Additions and Corrections

This report includes additional information and technical errors found between June 15, 2000, and April 1, 2003, in the inch-pound (I-P) edition of the 2000, 2001, and 2002 *ASHRAE Handbooks*. Occasional typographical errors and nonstandard symbol labels will be corrected in future volumes. The most current list of Handbook additions and corrections is on the ASHRAE web site (www.ashrae.org).

Fig. 22 Basic Heating System Schematic
(2000 HVAC Systems and Equipment, Chapter 11, p. 27)

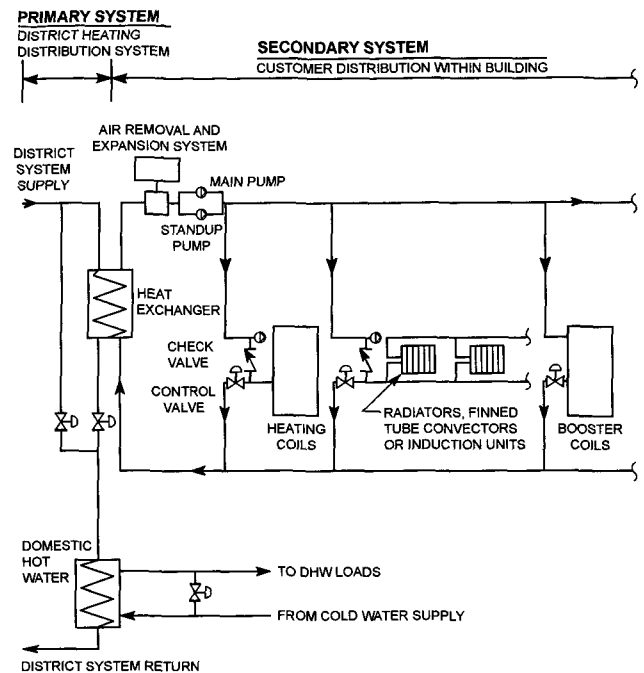
p. 11.27, Fig. 22. Replace Fig. 22 with the figure at top right, in which the primary and secondary systems are not shown to be connected.

Fig. 2 Stack Designs Providing Vertical Discharge and Rain Protection

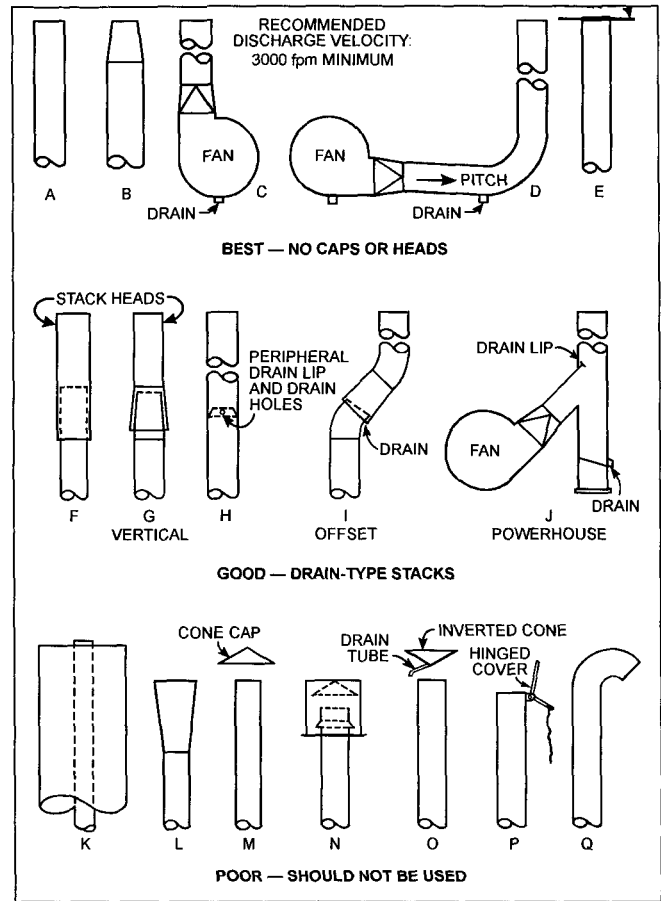
p. 34.23, Example 9, 2nd paragraph, 2nd line. Change “Figure 13 in Chapter 16” to read “Figure 2 in Chapter 43 of the 1999 ASHRAE Handbook—HVAC Applications.” Figure 2 is presented at right for convenience.

Fig. 1 Friction Loss for Water in Commercial Steel Pipe (Schedule 40)
(2001 Fundamentals, Chapter 35, p. 6)

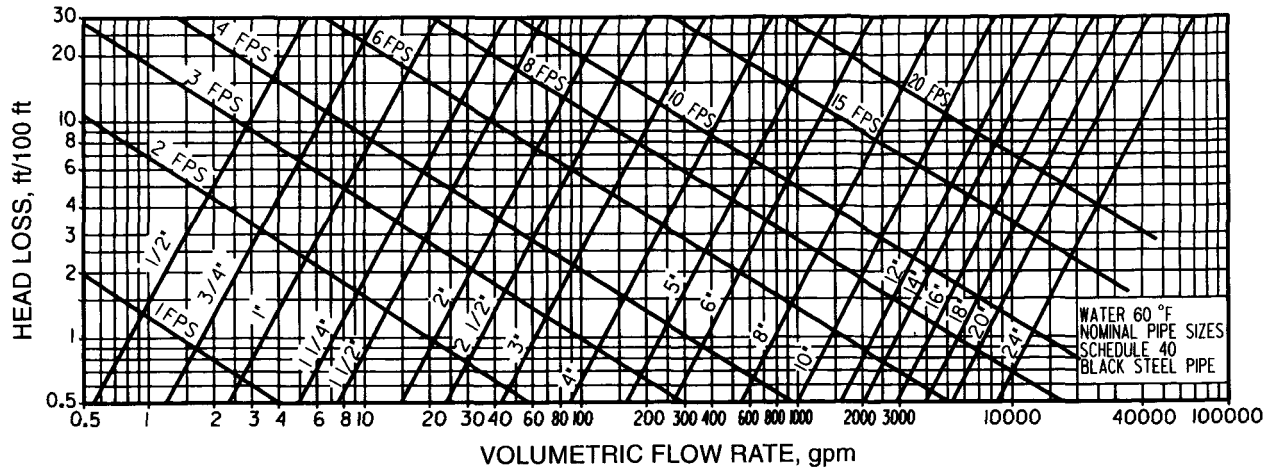
p. 35.6, Fig. 1. Replace Figure 1 with the corrected figure shown at the top of page 3.
